**PART 5: Development Presentations**

**Item 5.2**

Ref: 17/05566/PRE  
 Location: Part of Car Park, Wandle Road, Croydon CR0 1DX  
 Ward: Fairfield  
 Description: Presentation of a pre-application scheme for the erection a residential building of part 5, 23 and 25 storeys to accommodate approximately 130 flats and 950m2 of flexible office, retail and restaurant space; landscaping and public realm works; access and other associated works.  
 Drawing Nos: N/A  
 Applicant: Alison Brennan – Brick by Brick  
 Agent: Peter Twemlow – DP9  
 Case Officer: Richard Freeman

▲ Fig 10. Ground floor entrance and public realm

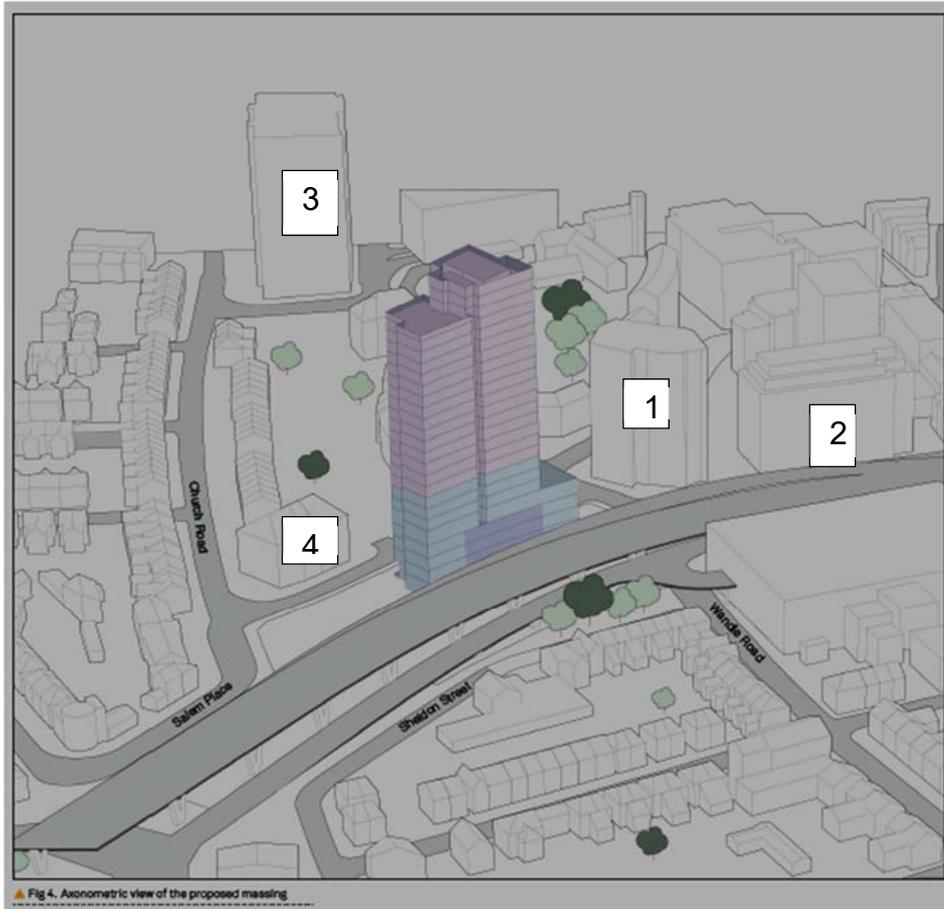
- The landscaped area onto Wandle Road (adjacent to the commercial entrance) needs to be further developed to balance defensive planting against openness and relate more closely to the building. The design of the public route across the site also needs to be developed further along with the proposed service area.

- The ground floor has low levels of activity to Scarbrook Road and a convoluted approach to the residential entrance, exacerbated by level changes necessary to overcome flood risk issues. Plant and storage areas should be as efficient as possible and the flexible use area connected to the residential lobby to increase activity.

- The flexible use area is currently ill-defined. If it is to operate as a standalone café unit, officers consider it is unlikely to be successful given the difficult location adjacent to the flyover and tall buildings.
